MEMORANDUM

SUBJECT: Camelback Planned Unit Development – C814-86-023.01

Camelback PUD

C814-86-023.01

Proposed PUD: Shoreline and Wetlands

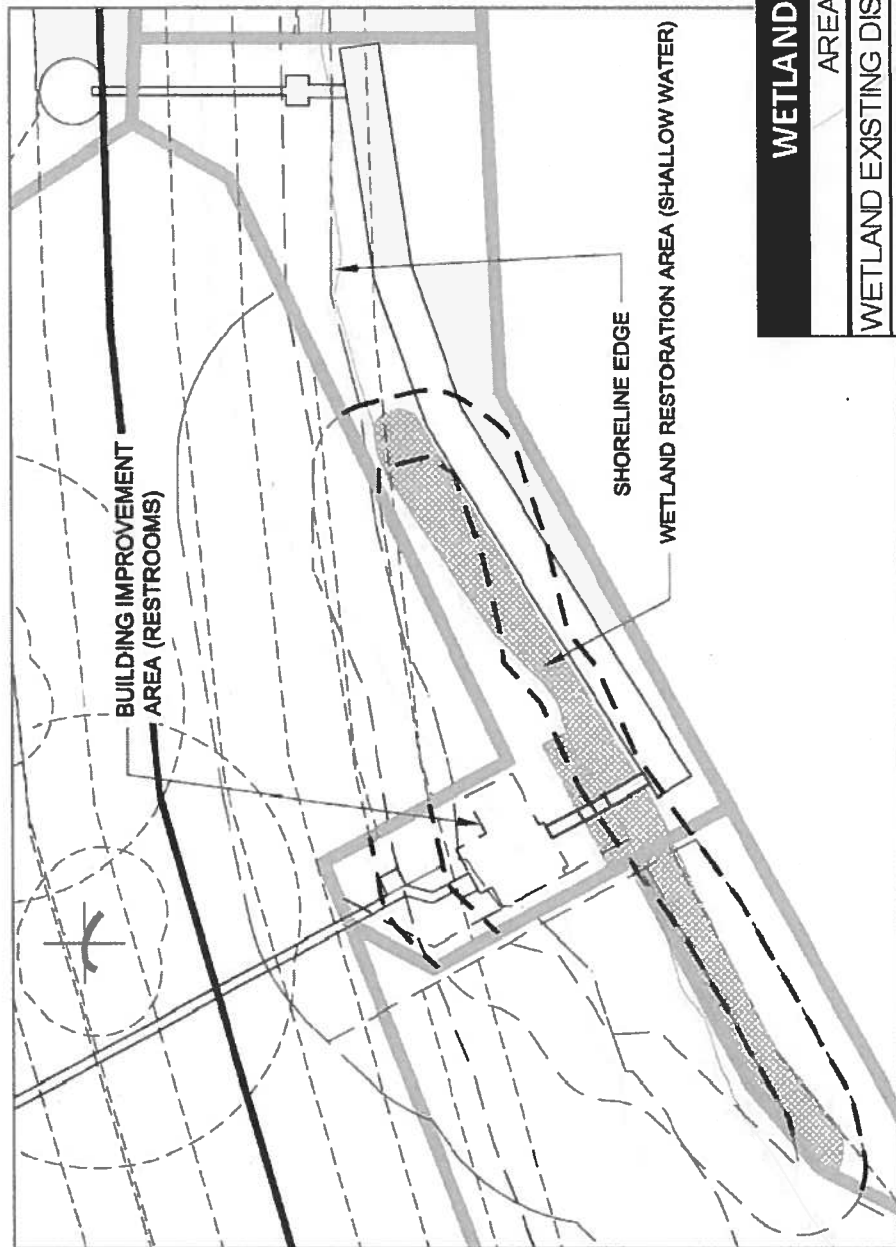
WETLAND CDEF W-6 MITIGATION SUMMARY	
AREA DESCRIPTION	SQUARE FEET
WETLAND EXISTING DISTURBED AREA	57,849.35
WETLAND PROPOSED DISTURBED AREA	13,133.23
WETLAND RESTORATION AREA	23,177.06

Proposed PUD: Boat Dock and Access

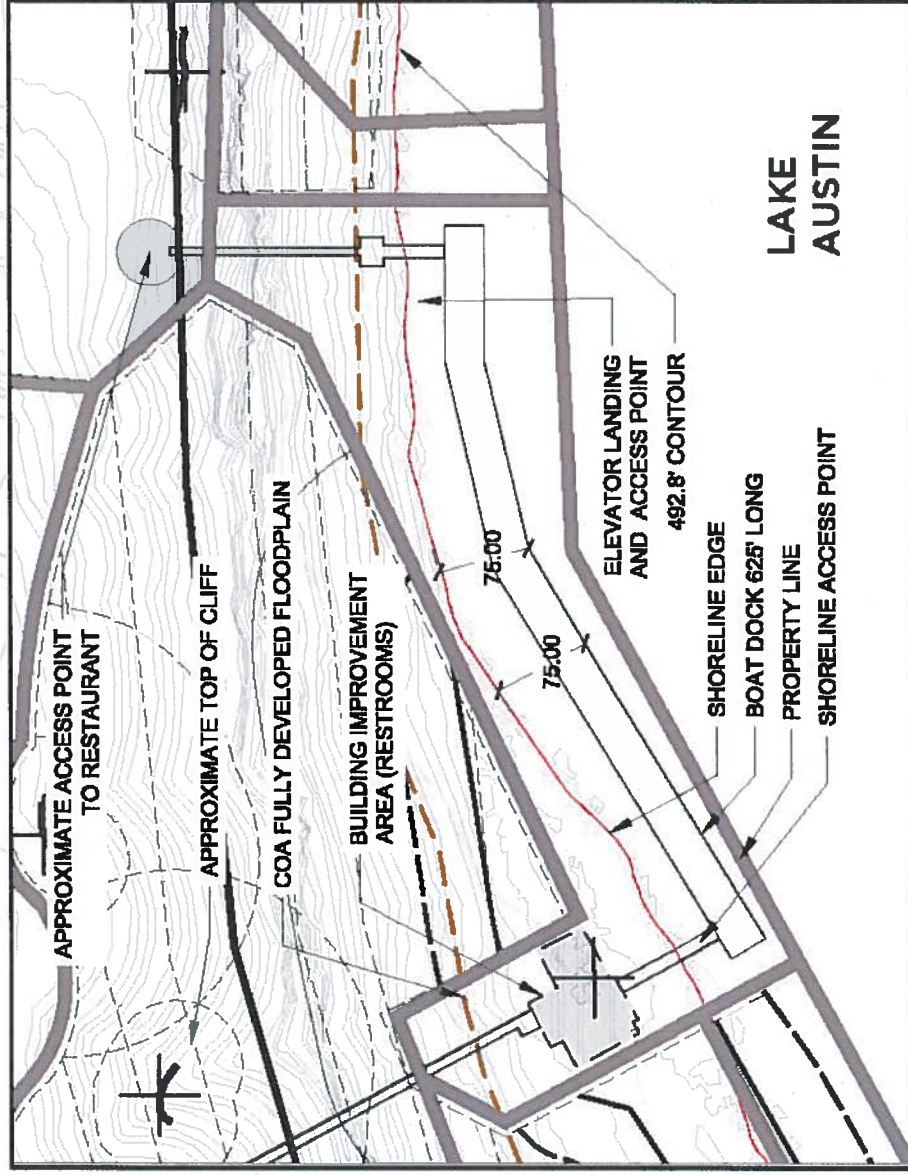
support mechanized shoreline access. However, staff conclude that the elevator would result in less disturbance and negative environmental impact than the incline elevator. Either the incline elevator or the elevator shall span the critical environmental features such that no structural connections to the vertical face of bluff or rimrock are utilized. Any mechanized access shall utilize a non-hydraulic method or redundant fluid containment if a hydraulic method is used.

7. The proposed PUD includes a cluster dock for private use only that is 18,720 ft² in footprint. While the cluster dock would comply with the 30 ft length requirement of current code, the cluster dock is proposed to be located up to 75 ft from the shoreline to minimize dredging and shoreline disturbance. Dock construction would occur by barge from the lake to minimize impacts to the shoreline and critical environmental features. All motorboats will be moored or stored within the dock footprint. Other than in the Dock (D), no other docks will be allowed along the shoreline. No shower facilities, fuel storage, or commercial watercraft rentals are allowed on the dock. No intense recreational use shall be allowed within the Shoreline Recreation Area, and swimming areas within the Dock District shall be restricted in size and location to be protective of public safety, navigation safety, and shoreline integrity.

Existing Code	Existing PUD	Proposed PUD
Cluster boat dock is limited by residential units 600sf/unit	12-2 slip docks Total = 14,400 sf	625 lf dock Total = 18,750 sf

Existing Code	Existing PUD	Proposed PUD
No Mechanized Access	No Mechanized Access	Mechanized access 1. Elevator 2. Tram

- The proposed PUD includes a cluster dock 18,720 ft² in footprint. The Environmental Commission has recommended that the cluster dock be limited to 14,400 ft² in footprint.

- The proposed PUD includes a cluster dock that is 30 ft in length but may extend up to 75 ft from the shoreline. The Environmental Commission recommended an evaluation of reducing the distance of the dock from the shoreline to 60 ft to reduce the potential for navigation safety concerns. Bringing the proposed dock closer to the shoreline would substantially increase the amount of dredging necessary and may reduce the area proposed for wetland restoration. Watershed Protection Department staff prefer limiting the amount of dredging and impacts to the shoreline over bringing the dock closer to the shoreline.

Proposed PUD: Heritage Trees

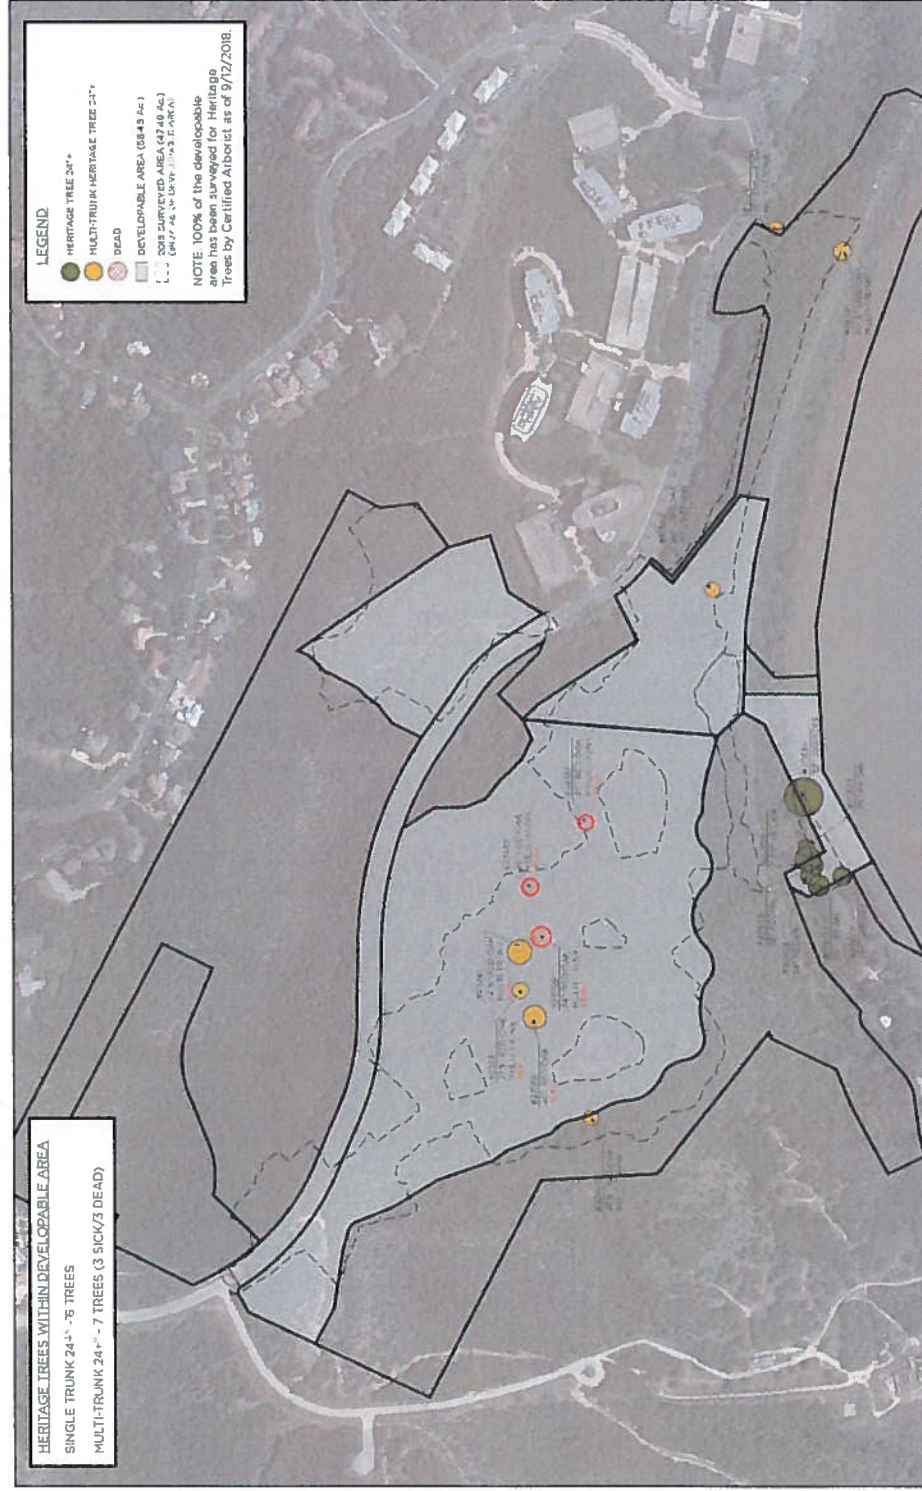
Existing Code	Existing PUD	Proposed PUD
Current Code	Protect trees greater than 19"	Current code except administrative removal of heritage trees identified as dead or diseased. Specifically Trees #: 23179, 23231, 23381*, 23399, 23472*, 24317*

*Tree health to be verified before PUD goes to Planning Commission

- Verify the trees listed are dead or dying per the applicant's arborist report
- Work with staff to establish a minimum buffer for the bluff
- Tram/elevator/inclinators need to be finalized with safety and environmental constraints as applicable
